SUBMITTAL TRANSMITTAL

April 16, 2012
Submittal #: 13121-003

PROJECT: Harold Thompson Regional WRF
Birdsall Rd.
Fountain, CO 80817
Job No. 2908

SUBJECT: Pumping and Disinfection Metal Building, Roof System, Textureclad Wall Panels,
and Liner Panels

SHEET
PD-3A
 OF

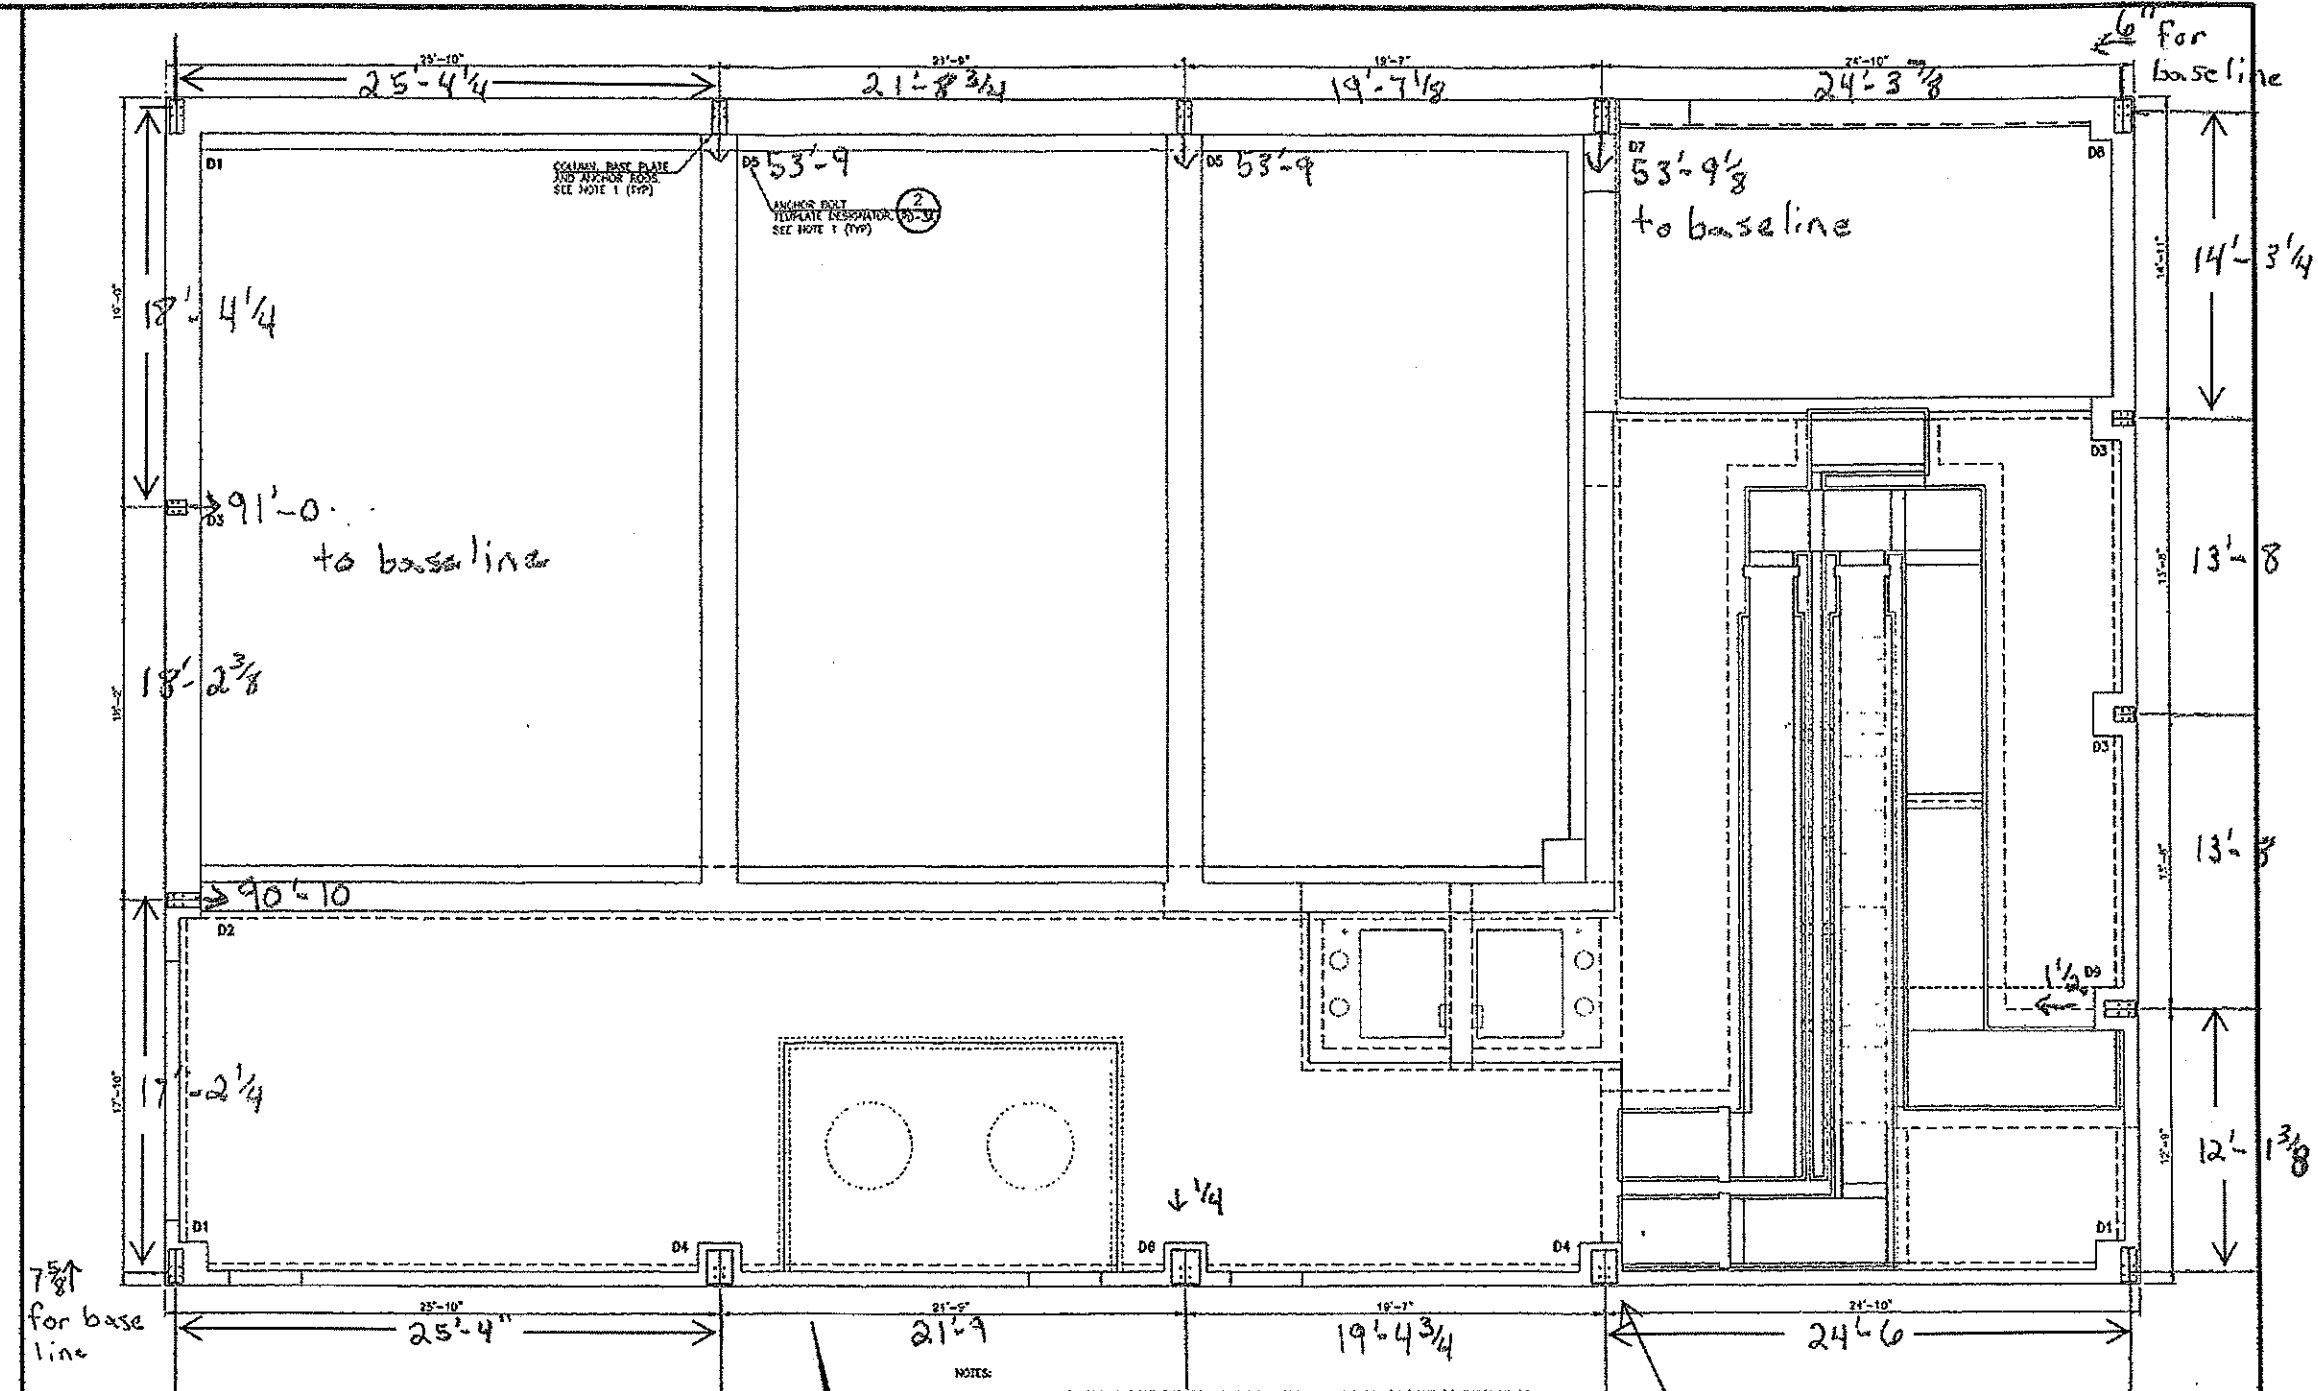
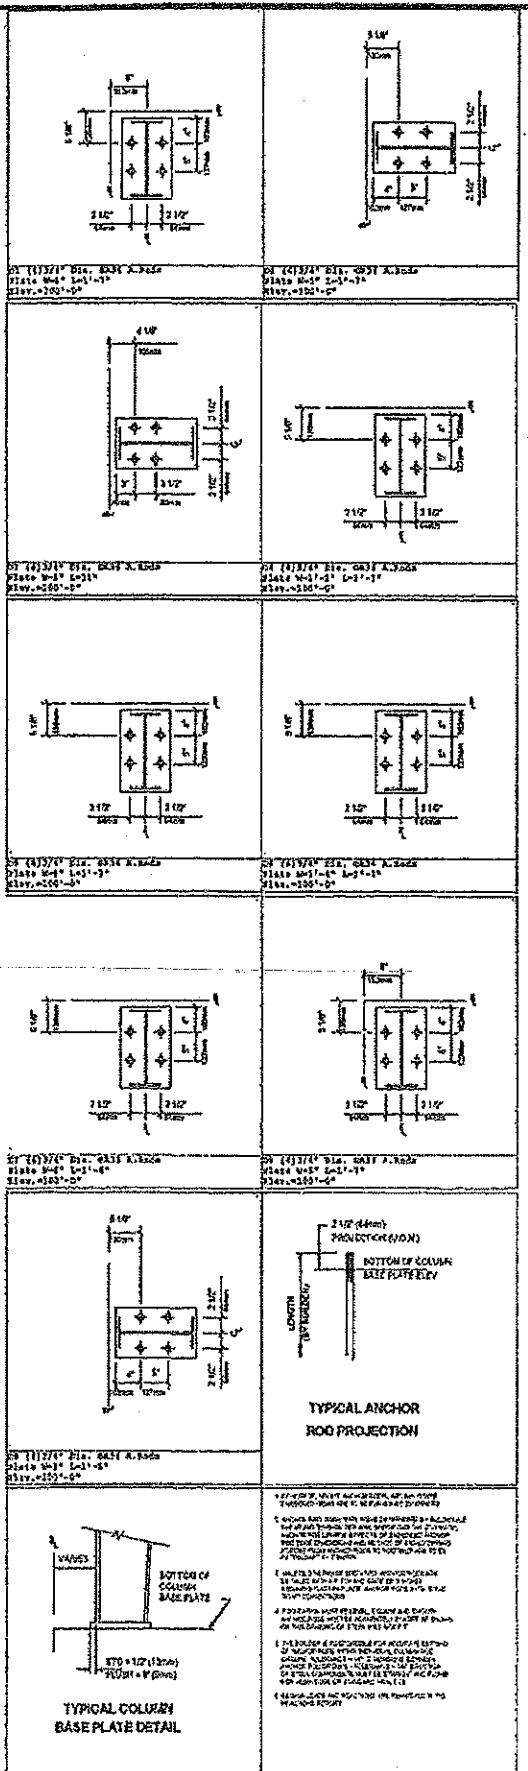
1. In addition to the metal building, this submittal also includes product data for the roof system, Textureclad wall panels, and liner panels
2. Page – 3 WCM provided Lefever as-built conditions of the anchor plates on March 27, but these as-builds do not appear to have been included within Page 3. WCM has included another copy of the as-build conditions per the attached Sheet PD-3A. Page 3 and all other pages affected by Page 3 shall be changed to include these as-builds.

This bolt pattern is 2" West of where it should be.
